Access Design Assessment Report

Penrith Log Cabin Pub  
Lots 20, 21 & 22 Memorial Avenue  
Penrith NSW 2750

Project: Penrith Log Cabin Pub  
Document Type: Access Design Assessment Report  
Our Reference: P219\_539-1 (ACCESS) JLS

**Figure 1 – Pedestrian Entries**

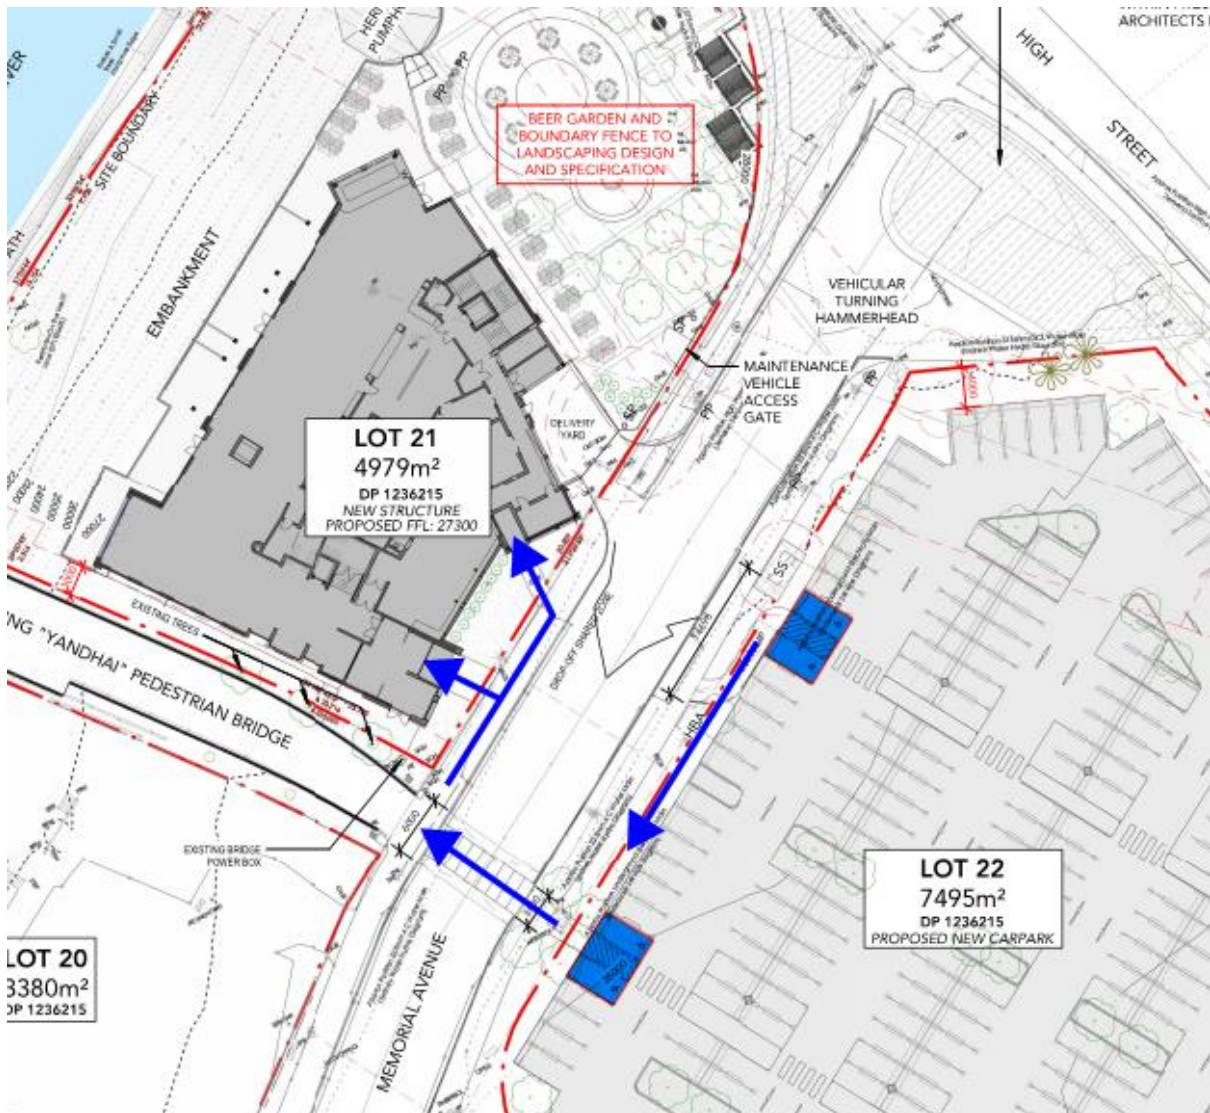
DESCRIPTION	COMMENT	RESOLUTION
Ramps	The proposed 1:15 ramps from the pedestrian footpath are noted as not being setback from the site boundary.	The 1:15 ramps are to be setback from the site boundary a minimum 1200mm to ensure a level landing is provided at the base or the ramps and TGSIs and handrail extensions to not protrude outside the boundary and into the traverse path of travel, compliant with AS1428.1-2009.
Ramps	TGSIs and handrails have not been shown to be provided to the entry ramps.	TGSIs to be provided at the top and bottom landings of the entry ramps, compliant with AS1428.1-2009 and AS1428.4.1-2009.  Handrail to be provided to both sides of the ramps, compliant with AS1428.1-2009.

DESCRIPTION	COMMENT	RESOLUTION
VIP Entry Door	The VIP entry sliding door is provided with latch side clearance of less than 530mm to both sides of the door.	If this door is not automatic opening via a motion activated sensor or push button, ensure a minimum latch side clearance of 530mm is provided to both sides of the doorway, compliant with AS1428.1-2009.

Proposed Ground Floor Plan

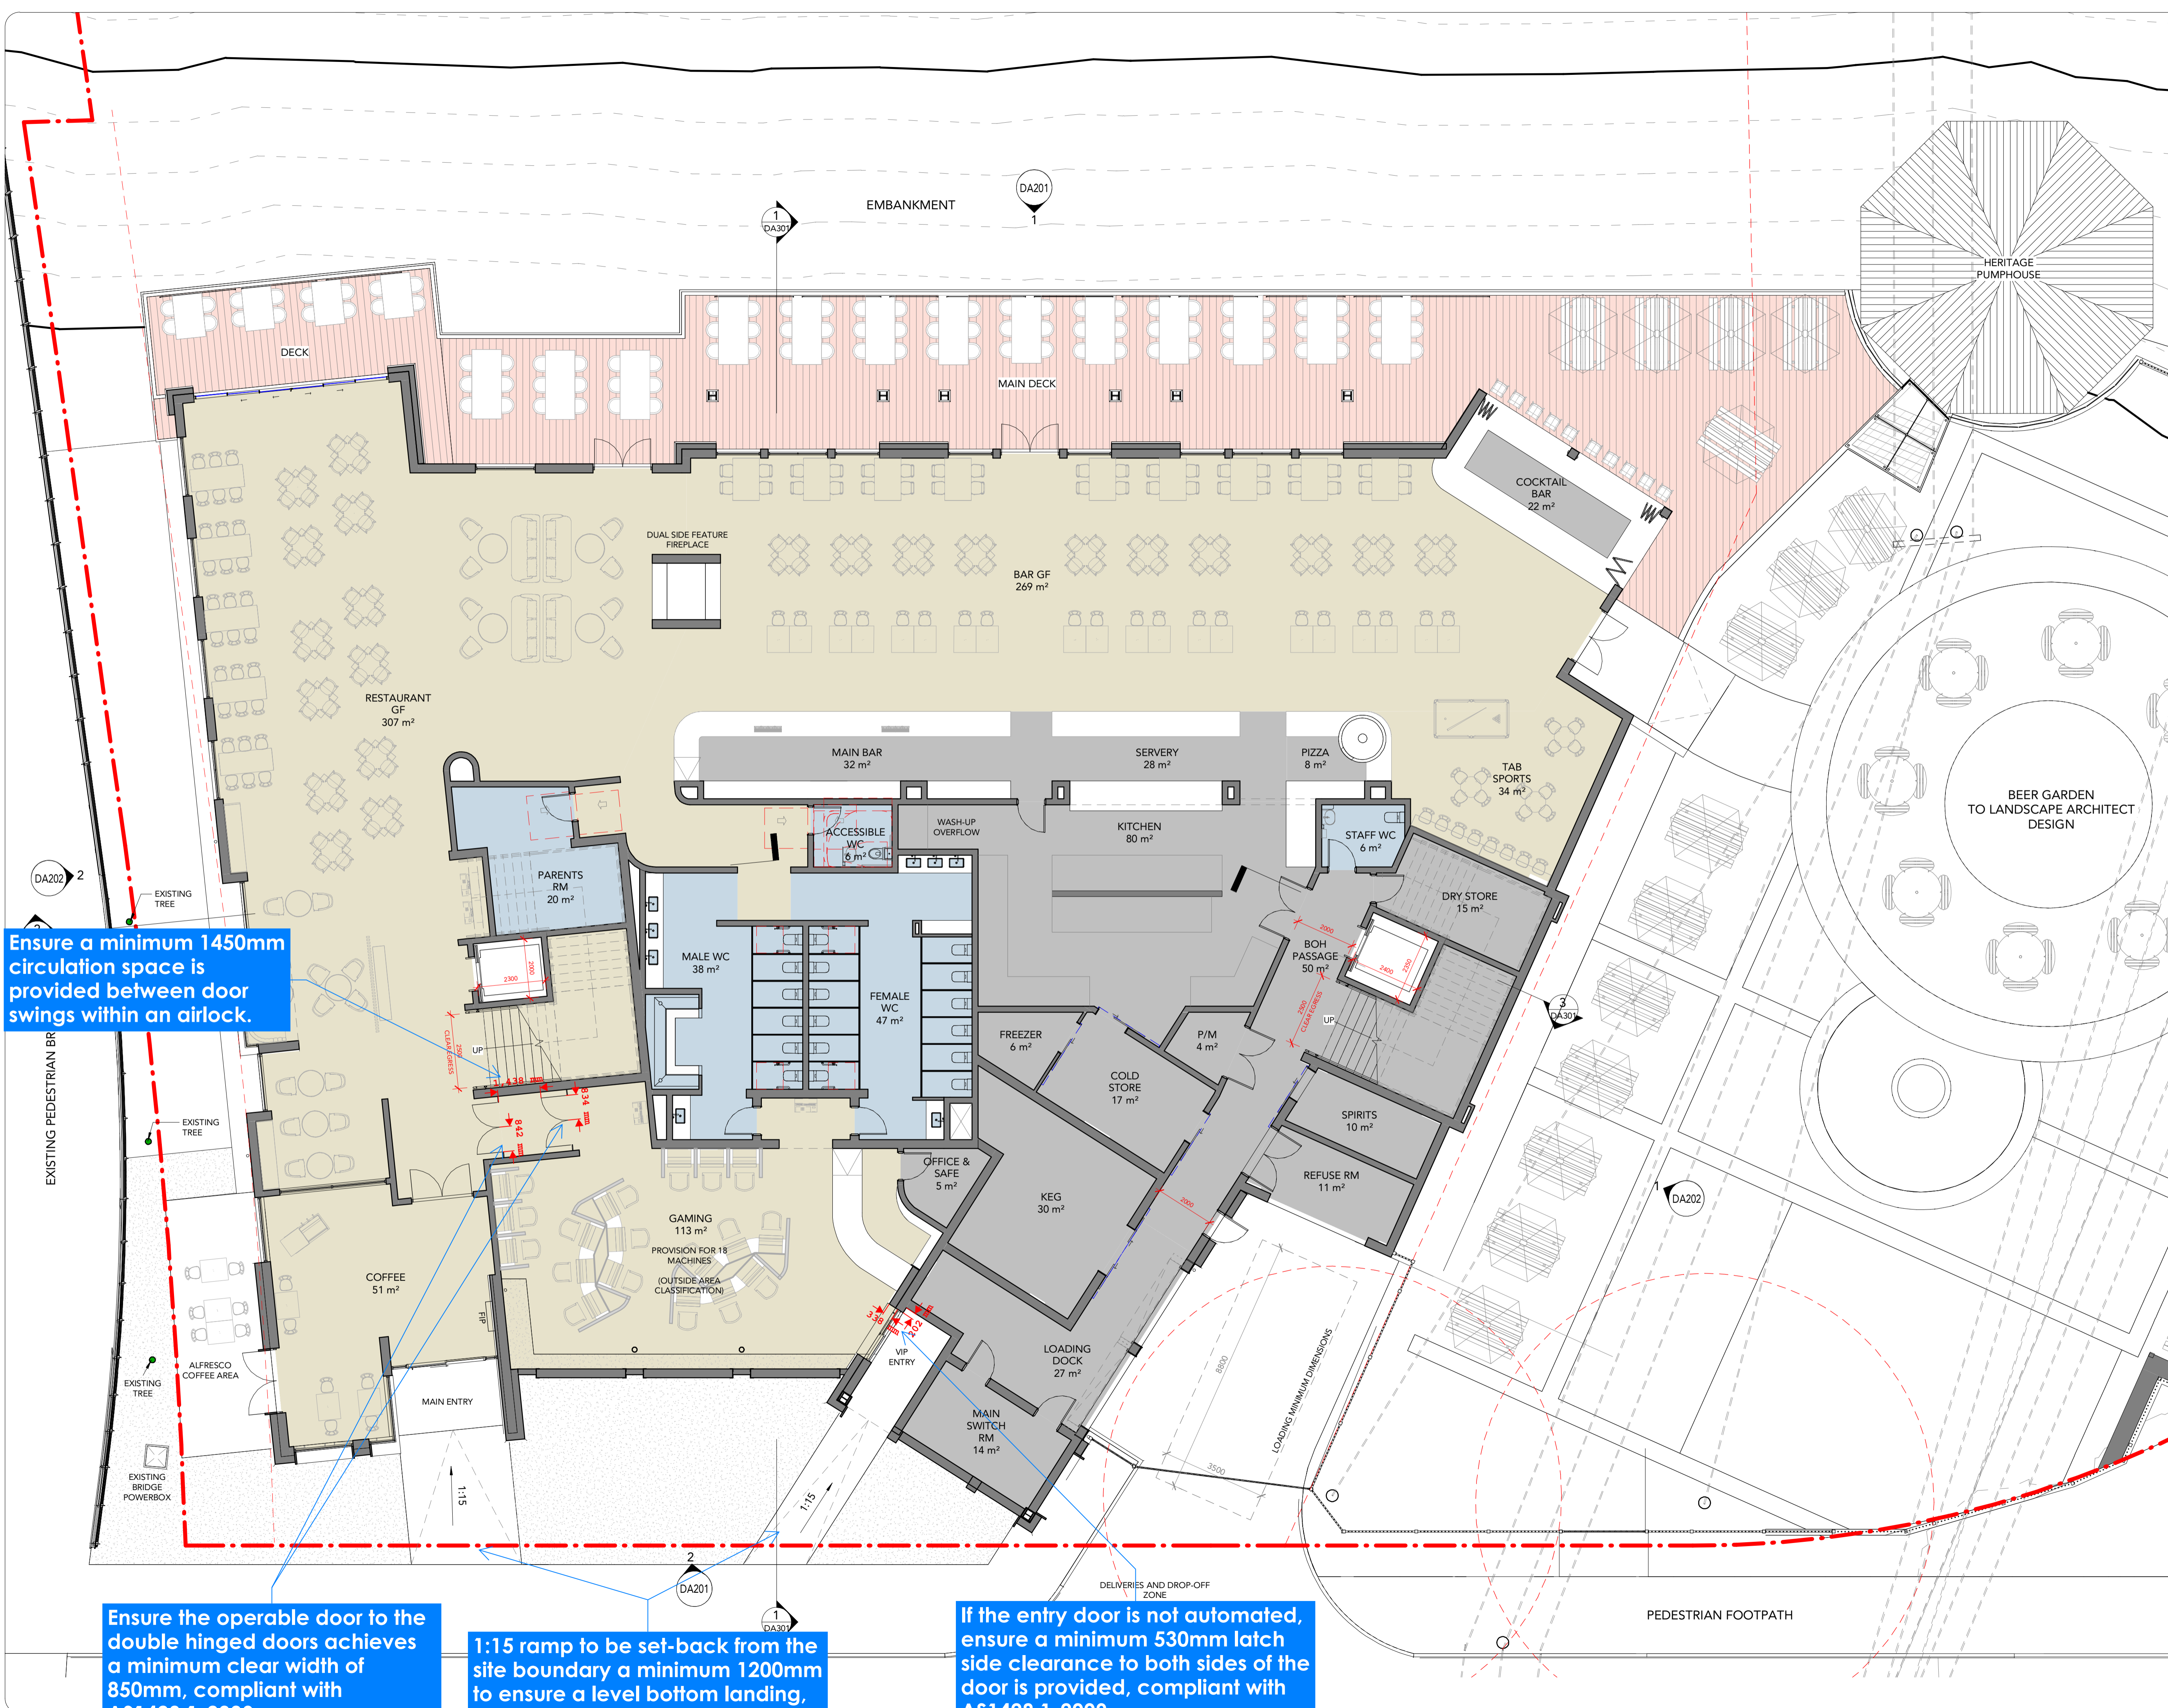
Ensure a minimum 1450mm circulation space is provided between door swings within an airlock.

Ensure the operable door to the double hinged doors achieves a minimum clear width of 850mm, compliant with AS1428.1-2009.

1:15 ramp to be set-back from the site boundary a minimum 1200mm to ensure a level bottom landing, compliant with AS1428.1-2009.

Proposed First Floor Plan				
Project #	Scale	Drawn	Checked	Client
905	1:100 @A1	JP	ZA	
Drawn	Scale	Checked	Client	
DA101				7

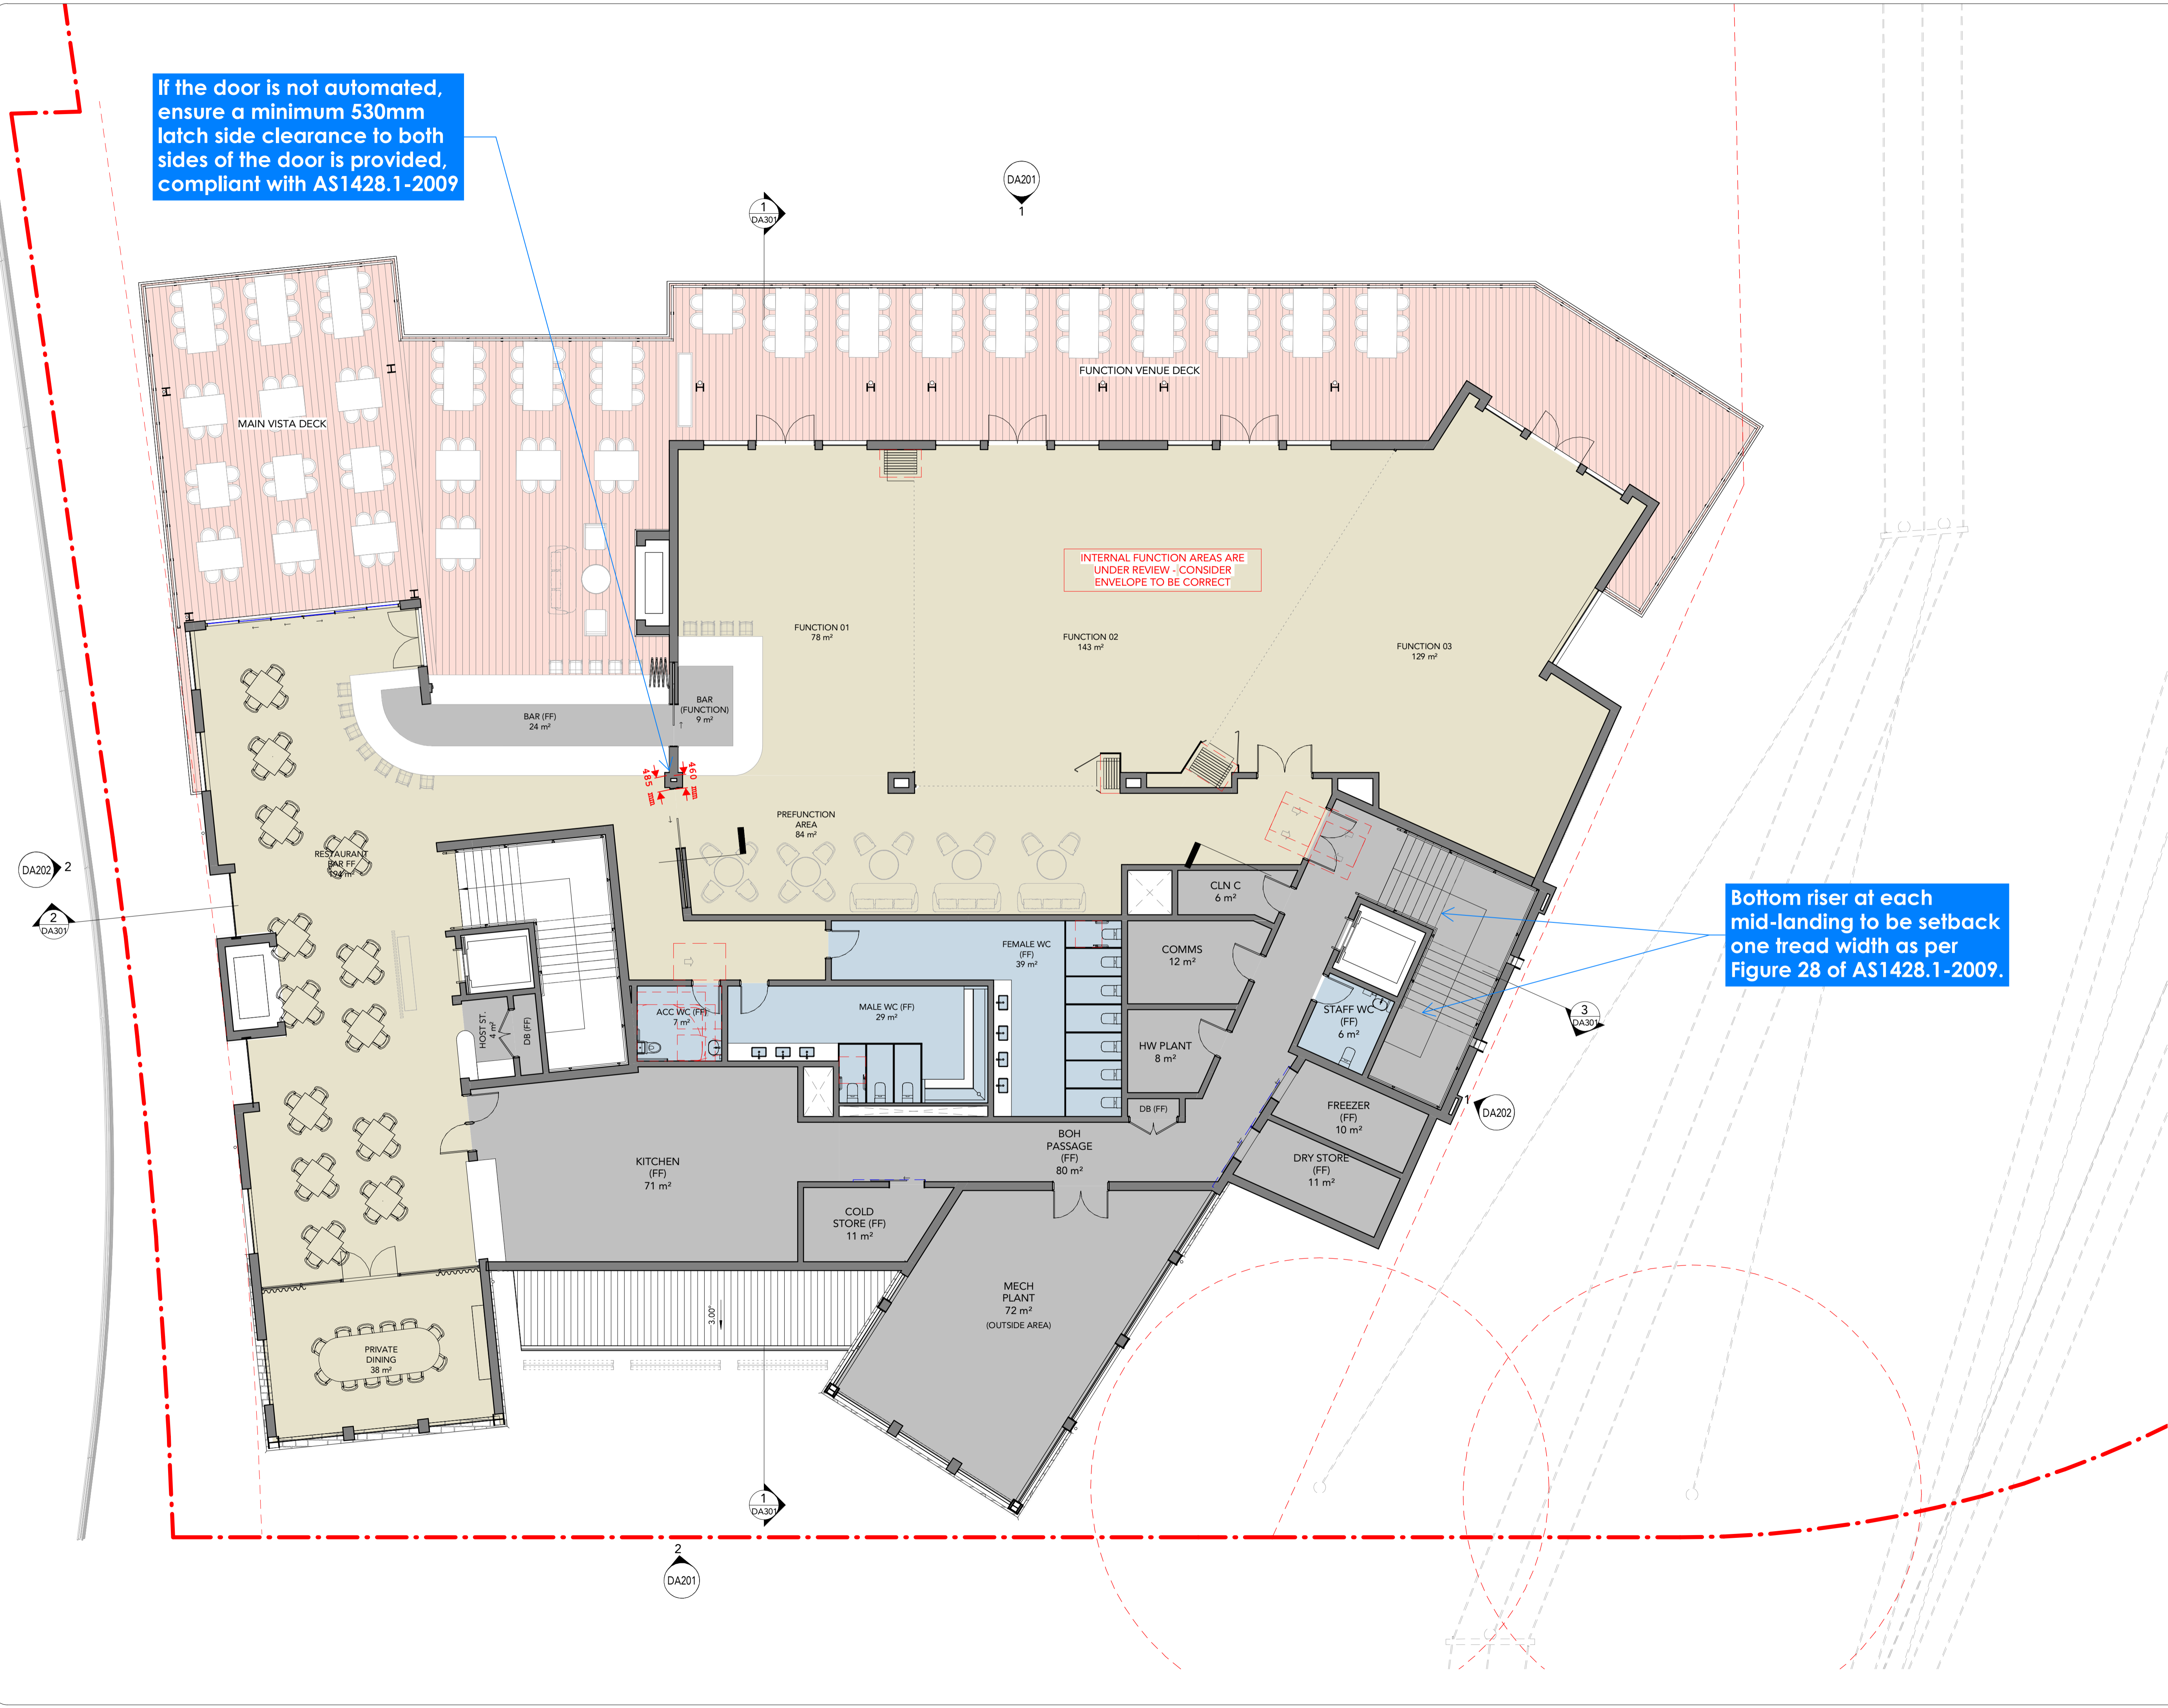
Bottom riser at each mid-landing to be setback one tread width as per Figure 28 of AS1428.1-2009.
